**SUBJECT:** New Alternator Belt  
**VEHICLES:** TESTAROSSA

A new "Poly V" 4 ribs type alternator belt has been introduced.

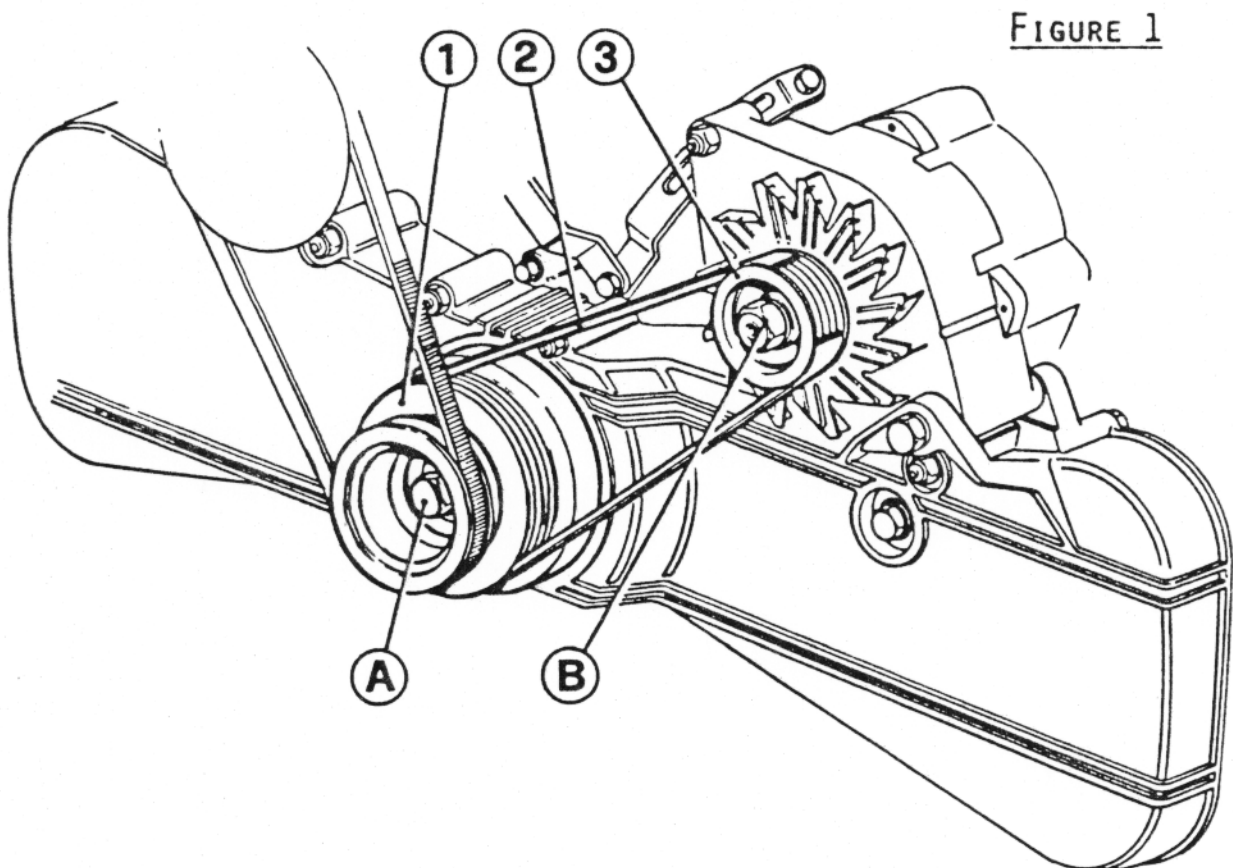
The new parts installed with the introduction of the mentioned belt are shown in Figure 1, and described in the following table.

REF.	PART NO.	DESCRIPTION
1	134145	Dampner
2	133262 or 133294	Alternator Belt "Poly V" (Pirelli) Alternator Belt "Poly V" (Continental)
3	134147	Alternator pulley

A - The bolt A (Fig. 1) for the engine dampner must be installed with loctite CAT 242 and torqued at 20 Kgm (145 ft.lbs).

- B - The nut B (Fig. 1), holding the alternator pulley, must be torqued at 6.0 Kgm (43 ft.lbs.).
- C - Tension checking to be performed with "KRIKIT 1" tension gauge (Ferrari P.N. 95970031);
  - C-1 INSTALLATION: adjust the tension at 45±50 Kg.
  - C-2 RE-TENSIONING: after 150 Km (100 mi) approximately, re-tension the belt to the initial specification (45±50 Kg).
